May 28, 2025

**RE: Ted Franciscotti Pit #1, Permit No. M-2007-006, Technical Revision (TR2), Adequacy Review No. 2**

**Figure 1:** Permit boundary orientation depicted within Mr. Franciscotti's parcels in the original permit application (before the 111 Huskin areas were added through adequacy conversations).

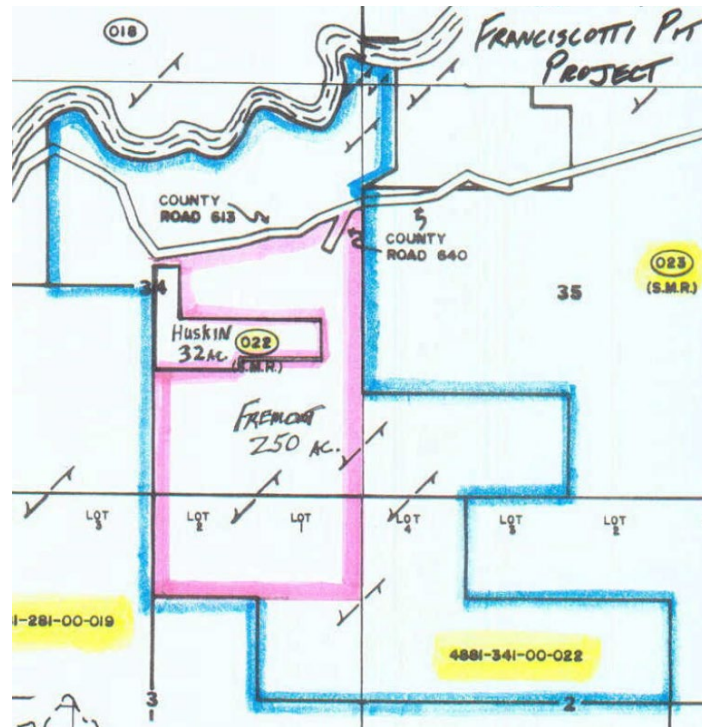
1.
  - a. Upon further review of the permit boundary submitted with the Adequacy No. 1 responses, it appears that it may need to be re-aligned. When comparing it to the Huerfano County Parcel data and to the original applicant's depiction of the permit area and the parcel boundaries, it appears that it was intended to be located solely on Mr. Franciscotti's land (see Figure 1). Please see Figure 2's depiction of the Division's estimate of the permit boundary based on the 282 approved acres, the parcel boundaries, and the shape depicted on the original applicant's maps. I have attached the KML file for the parcel boundaries and the Division's estimate within an email to the Applicant. If you concur with the boundary, please update and resubmit the maps.

**Figure 2:** The Division's estimate of the permit boundary lain within the parcel boundary information sourced from the Huerfano County Assessor's parcel data web page.

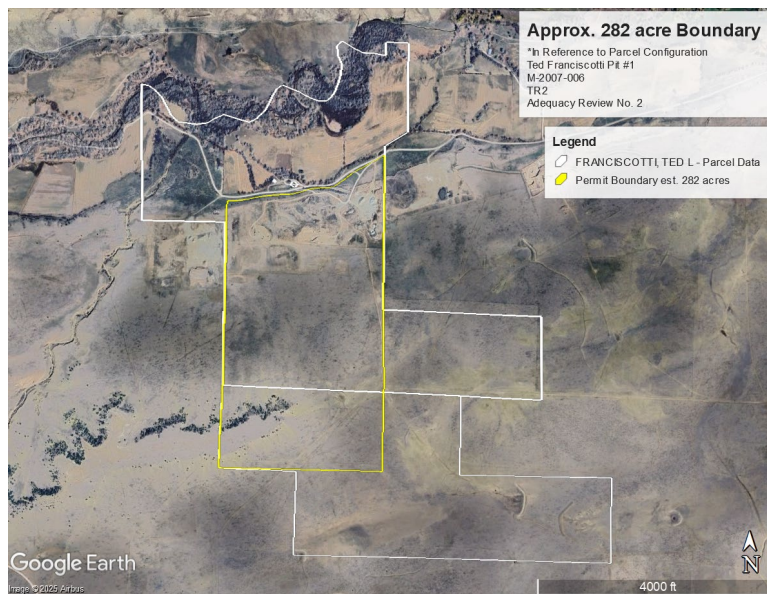
- b. Additionally, the Mining Map and Phase map state that the permit boundary is 281 acres, and the Reclamation Map states that it is 282 acres. Please ensure that they both reflect the currently approved 282 acreage.

Figure 5: Screenshot from the original/currently approved Mining Plan Map. The highlighted text indicates where a 30-foot buffer zone was planned around the boundaries.

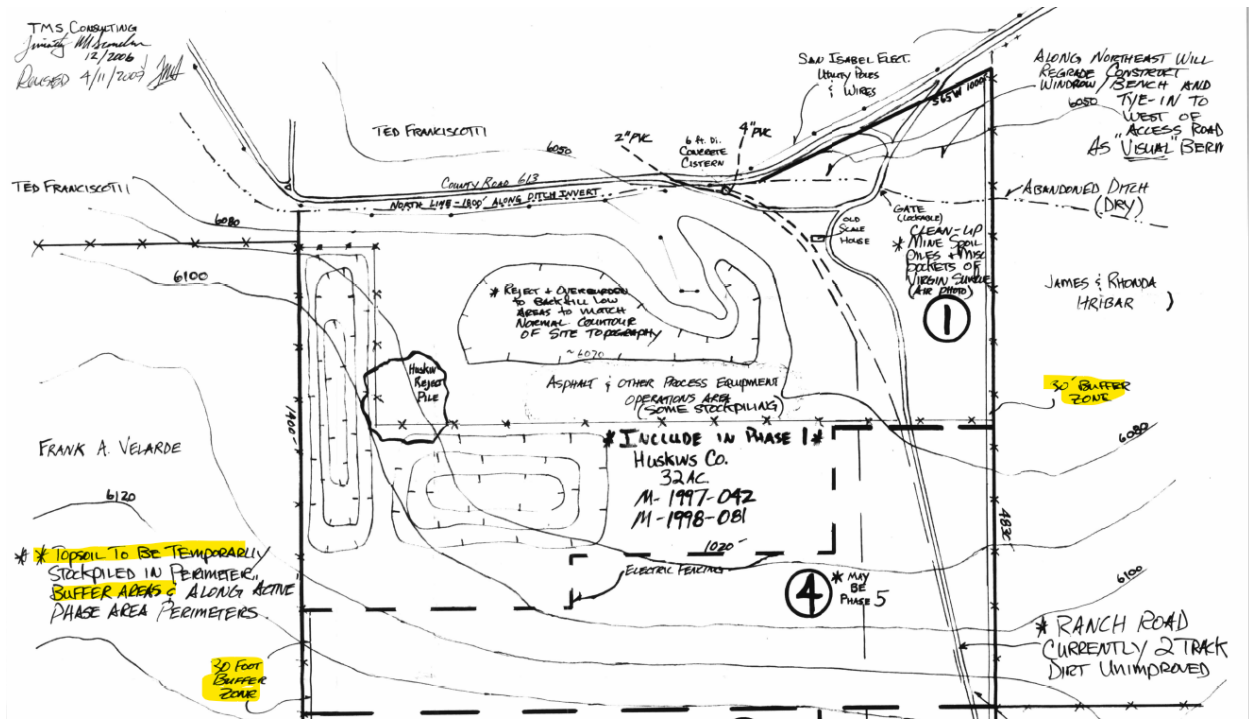
10. **DRMS Adq. 1:** The current Mining Map indicates that there will be a 30-foot buffer area around the permit area that will be used for topsoil stockpiling (see Figure 3 below). The Applicant's TR2 Mining Map appears to place the topsoil around this area in Phase I as well. Please clarify if the 30-foot buffer areas are to be maintained around where they are currently depicted – or if the Applicant instead intends to just ensure that topsoil is located outside of the ongoing mining activities in a perimeter configuration.

**Applicant Adq. 1 Resp:** The applicant intends to ensure that topsoil is located outside of the ongoing mining activities in a perimeter configuration.

**DRMS Adq. 2:** This may be further addressed in the Applicant's response to Adequacy item # 3 above.
